CITY PLAN COMMISSION STAFF REPORT

Chatham Ave Self Storage

CD-CPC-2024-00199

Plan Conditions, Corrections, & Suggestions Report

A1 BUILDING ELEVATION - NORTH
3/32" = 1'-0"

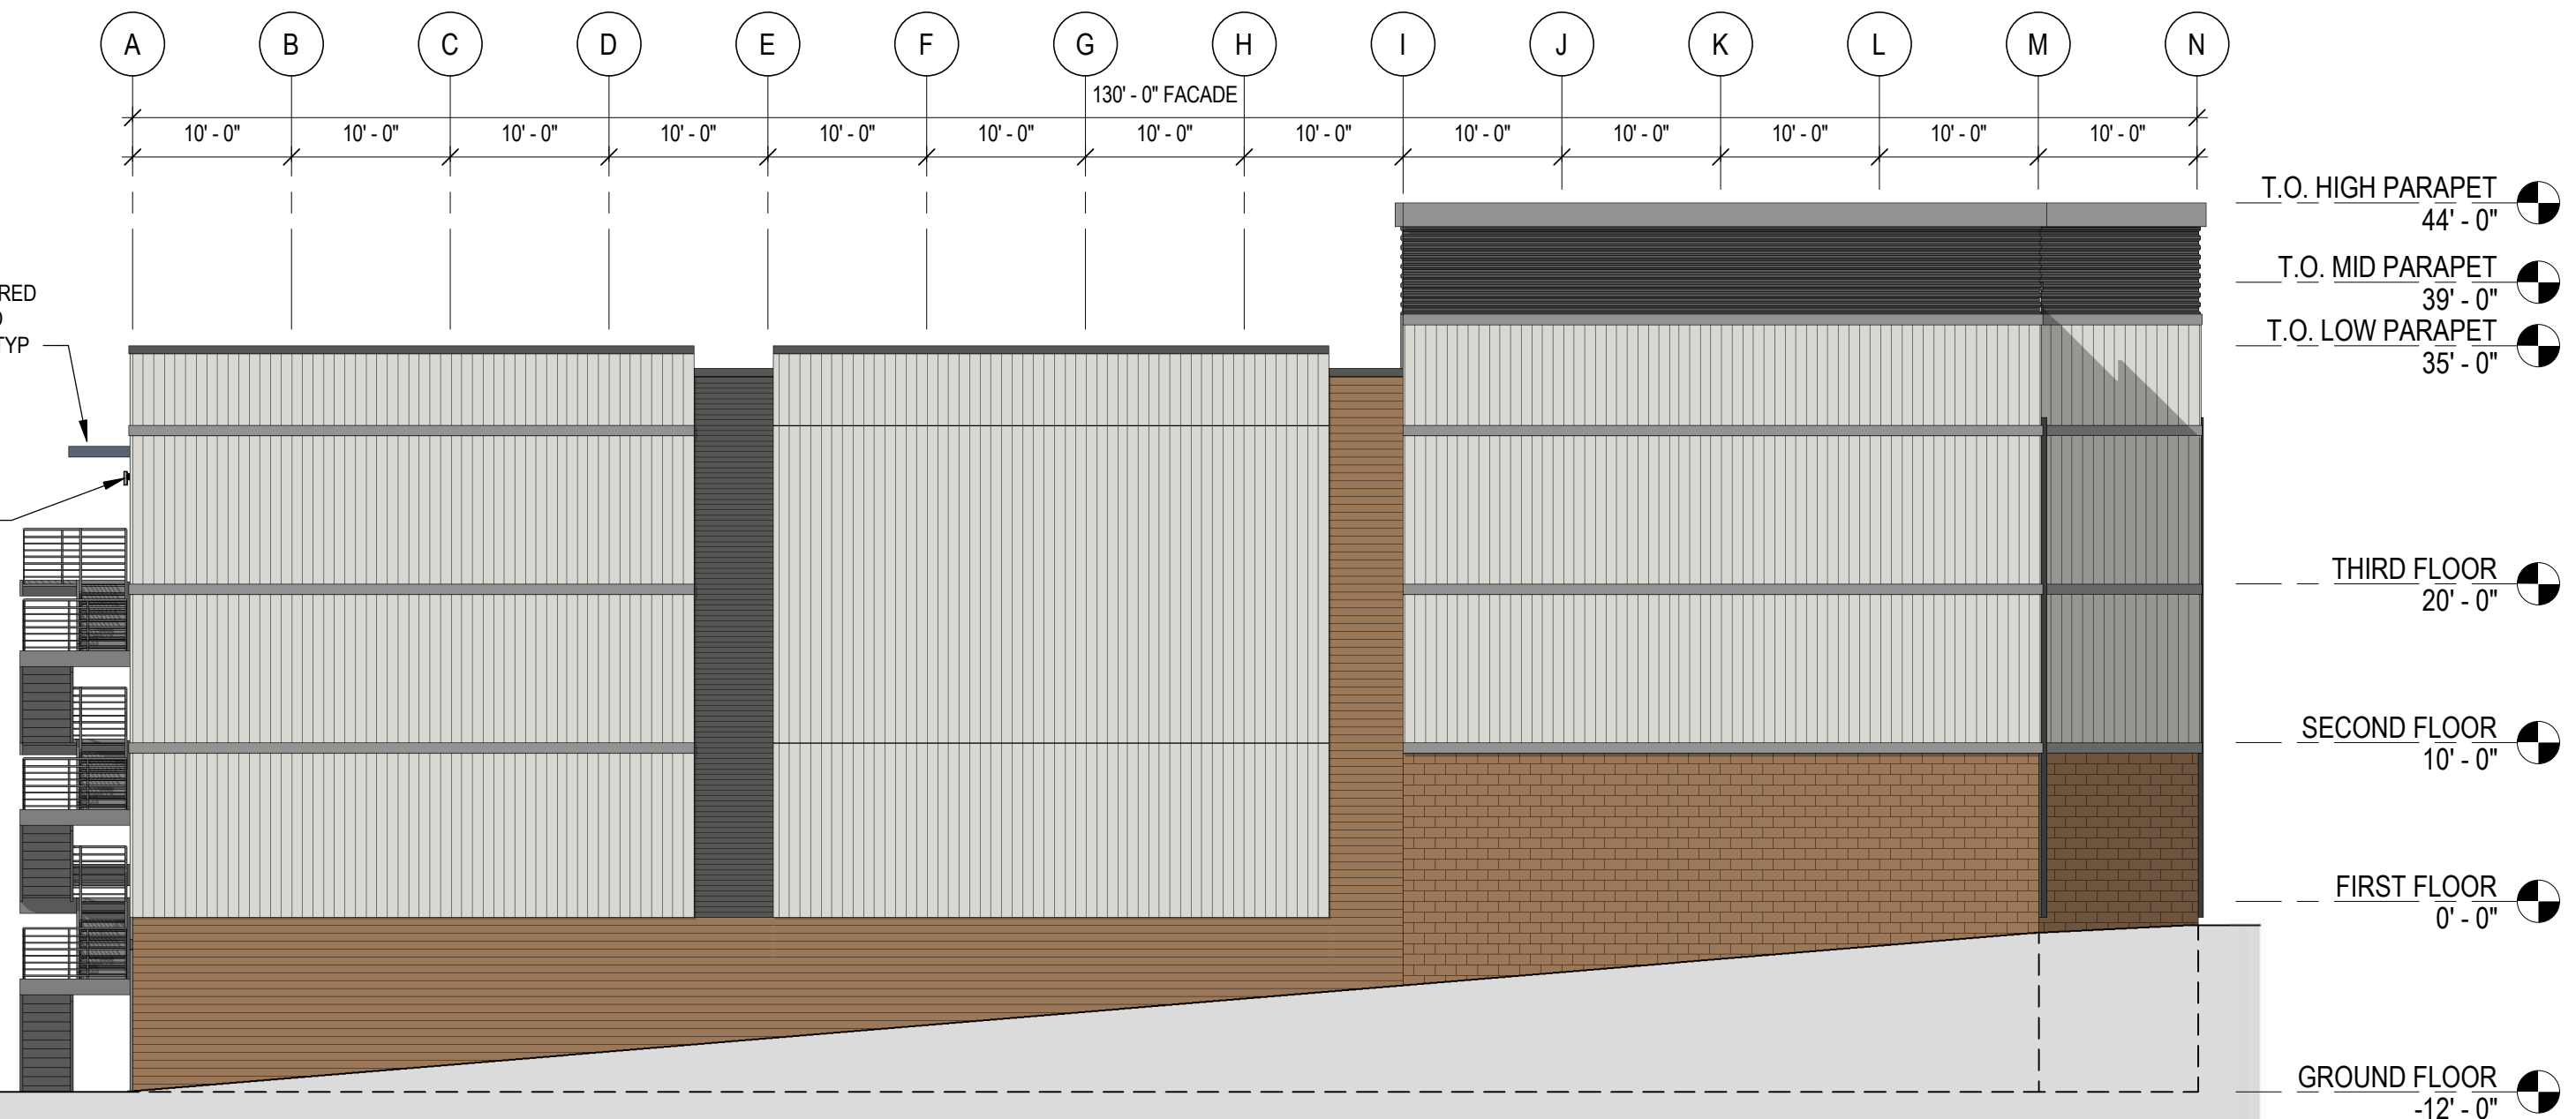
1. Per 88-369: Any wall abutting public right-of-way and over 75 feet in length shall include a combination of at least two of the following features: facade setbacks, change of building materials, varied roof line, a water table, or pilasters. Indicate which 2 features utilized on elevation sheets. UPDATE 1/23/25: Couldn't locate any notes identifying 2 of the above features on the plans as stated in the response letter. (1/21/2025)
